# 26 West Hill Park London N6 6ND

### 2017/5176/P

| Delegated Report  |              | Analysis sheet |                              | Expiry Date:                 | 08/12/2017 |  |  |  |
| Erection of 2 storey brick built side extension above existing swimming pool of single family dwelling (Use Class C3) |              |                |                              |                              |            |  |  |  |

Figure one – relationship between proposed extension and neighbouring properties

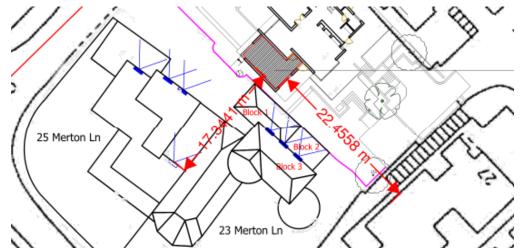
- 5.3. Nos.23 and 25 Merton Lane are those situated in closest proximity to the proposed extension and as such concern was initially raised with regard to the impact upon these neighbouring properties. In terms of natural light, as the extension would be almost due North of 23 and North East of 25 Merton Lane, officers do not consider there to be any risk of significant loss of daylight or sunlight into these adjoining properties. Similarly due to its orientation and siting, overshadowing is not of concern in this instance.

- 5.4. In terms of outlook, although the main aspect of both of these properties faces South West (towards the Heath), both dwellings do feature clear glazed windows at first floor level which face back up the hill towards the application site. Notwithstanding this due to its relative positioning the side extension would not project directly in front of any rear facing windows to these properties other than to the rear of the front wing of no.25 as demonstrated in figure one above. As this window would be situated over 17m from the proposed flank elevation and the existing view from this window would be the existing (larger) flank elevation, this relationship is not considered harmful. Similarly, although the extension would be visible in oblique angles from the other first floor rear windows to these properties, the minor infringement into the periphery of these views is not considered to constitute a detrimental loss of outlook that might warrant a reason for refusal.

- 5.5. In terms of privacy, the extension would not include side windows other than the wrap-around rear windows which was requested for reasons of design and conservation. Whilst the rear facing windows would essentially offer the same views as the existing rear facing windows, these warp around windows would allow views towards no.25 Merton Lane and as such officers considered it necessary to add a condition that these glazed panels should be obscured and non-opening. To the front, the extension would include glazing at ground floor level to serve the proposed art studio. While this glazing would be less than 10m from the aforementioned rear facing windows to no.23, these views would be oblique and are similar to the views afforded from the existing opening to the main lounge.

- 5.6. No.27 West Hill Park does not feature any side habitable room windows which face towards the site although it does feature a private terrace at 1<sup>st</sup> floor level in its Western corner where views are afforded towards the site. As this terrace is situated over 20m from the proposed extension and considerably to the South, the proposed extension would not result in the harmful loss of daylight, sunlight or privacy. Whilst officers acknowledge that the extension may project into the North Western views afforded from this terrace, more than half of the existing gap would be retained and with a distance of over 20m retained this would not be considered to result in a harmful loss of outlook (with no impact at all to the main Southern

Prior to the first use of the extension hereby approved, the glazing to the side windows of the extension at upper ground and first floor levels which face towards no.25 Merton Lane shall be obscured. The obscure glazing shall be permanently retained thereafter.
